DEPARTMENT OF HEALTH

NORTHWEST DRINKING WATER REGIONAL OPERATIONS

Livingston Bay Community Association President John Gablehouse 26910 92 nd Ave NW C-5 Pmb 412 Stanwood WA 98292	Livingston Bay Community ID #47628	
	County:	Island
	System Type:	A-Comm
	Operating Permit Color:	Green
	Surveyor:	Laura McLaughlin
	Inspection Date:	December 10, 2019

S01, well 1, Improved insulation

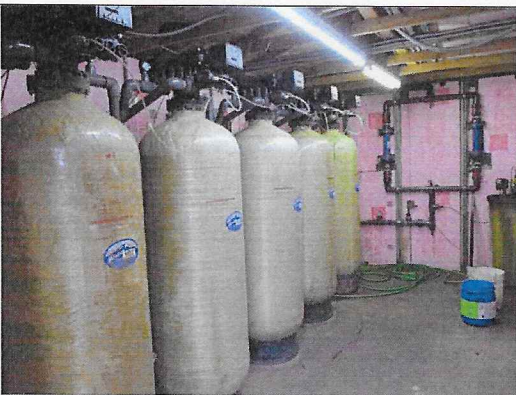
The well is located in a dog house next to the treatment building. The insulation has been replaced since the last survey, a good temporary fix. Consider replacing the enclosure and ensure it is isolated from the outside.

- The loose insulation at the wellhead attracts rodents. **You should replace the enclosure with a type that is well isolated from the outside and only use rigid foam board insulation or cover the wool with boards.** 2019 UPDATE: COMPLETE: reinsulated dog house.

Octagonal, newly lined tank

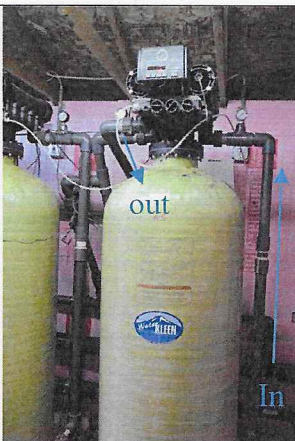
- c. Emergency response
4. While the liner and sealant repair to the crack in the tank roof seem to have improved the performance of the tank, liners and sealants run a risk of leaking/failing. Now that the tank seems to be working properly, it's a good time to **plan and budget for tank replacement**. Also, **examine the tank for structural stability and develop an inspection schedule to routinely inspect for tank and roof** for new cracks or leaks.

I have not yet received photos of the reservoir's hatch and vent, the repaired crack on the roof (see comments). While I understand the crack was repaired with a sealant, if it re-opens this crack could allow surface water runoff to enter into the reservoir. Develop a routine inspection schedule to ensure that a good seal is maintained and start planning for reservoir replacement now.

Tank corner with cracks

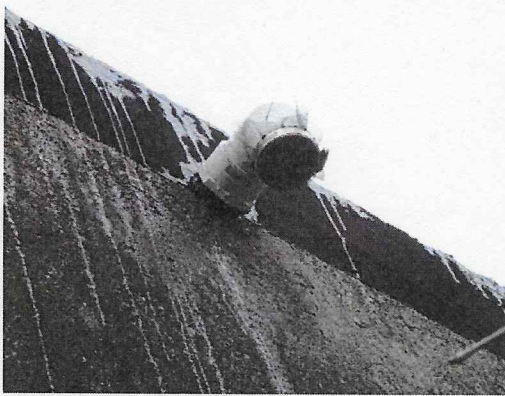
RESERVOIR	DESCRIPTION	TOTAL VOLUME (GAL)
1	60,000 gallon above ground octagonal concrete tank; several corners were leaking and the top has a crack. A new liner was installed in the tank since the last survey.	60,000

- The roof of the reservoir has a significant crack that may let surface water runoff into the tank. **Please investigate and repair as soon as possible to avoid significant contamination of your water supply.**
